LAKE TIMBERLINE DAM

NDI No. PA00977
PennDER No. 58-125
Dam Owner: Richard O'Reilly

PHASE I INSPECTION REPORT
NATIONAL DAM INSPECTION PROGRAM
PACW 31-81-C-0011

AUGUST 1981

PHOTO 2. View Across Spillway

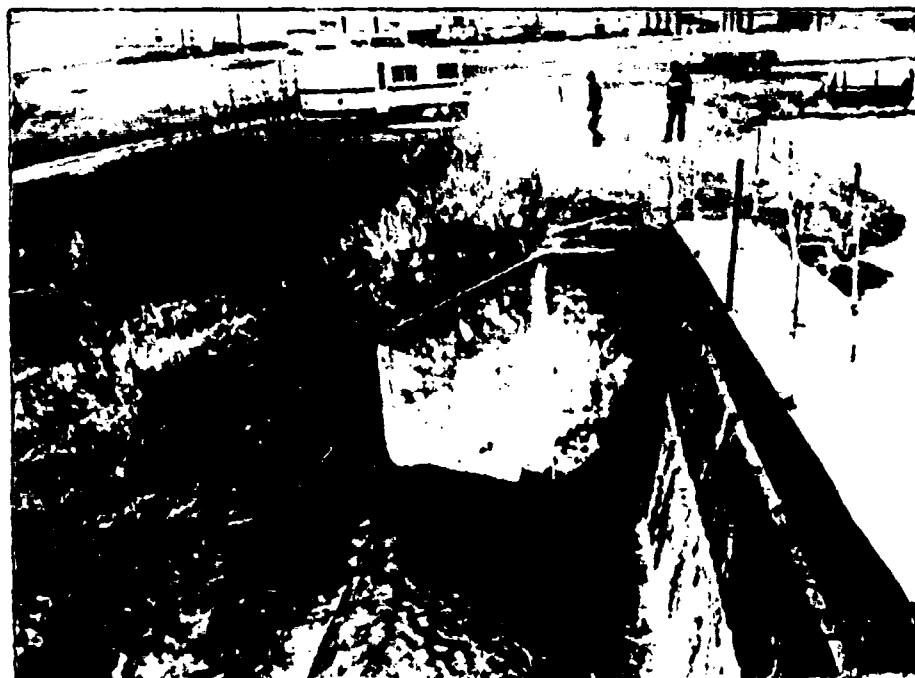
VISUAL EXAMINATION OF	OBSERVATIONS	REMARKS OR RECOMMENDATIONS
CONCRETE WEIR	No problems observed.	
APPROACH CHANNEL	No problems observed.	
DISCHARGE CHANNEL	There is erosion around both sides of downstream end of training walls. The owner reports installing free training material to relieve pressure on the training walls.	
BRIDGE AND PIERS	The footbridge is in poor condition.	Repair or remove footbridge.

PHOTO 5. View of Discharge End of Outlet Pipe

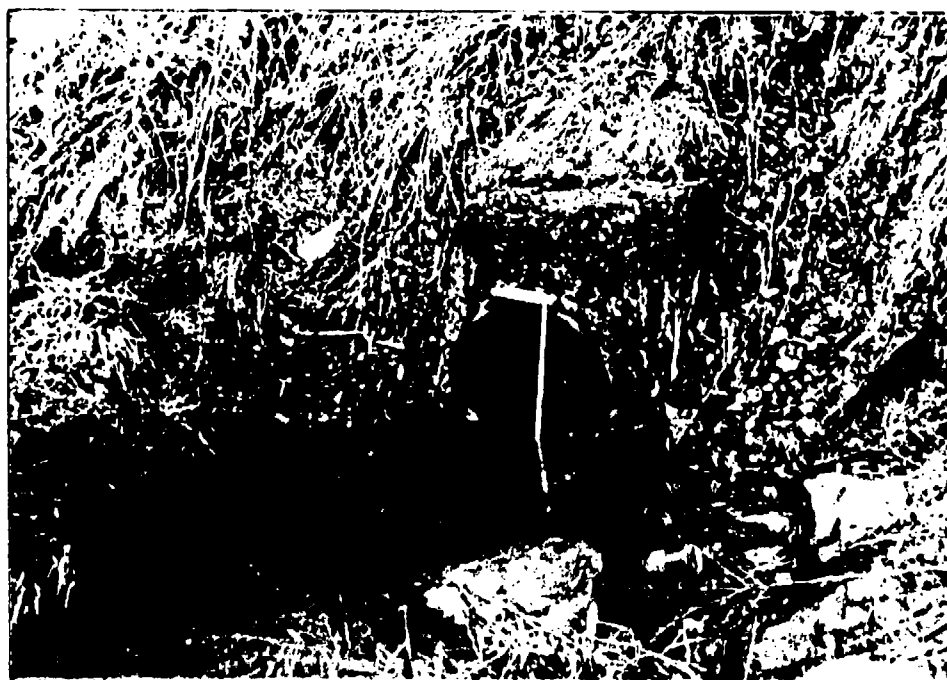
The outlet pipe is encased in a concrete headwall. A clear seep (est. 1 g.p.m.) was flowing from the toe of the embankment 2 ft. upstream from the end of the pipe. The outlet end of the pipe appears to be at a higher elevation than the entrance to the pipe.

Monitor seep in the future for increase in flow and/or turbidity.
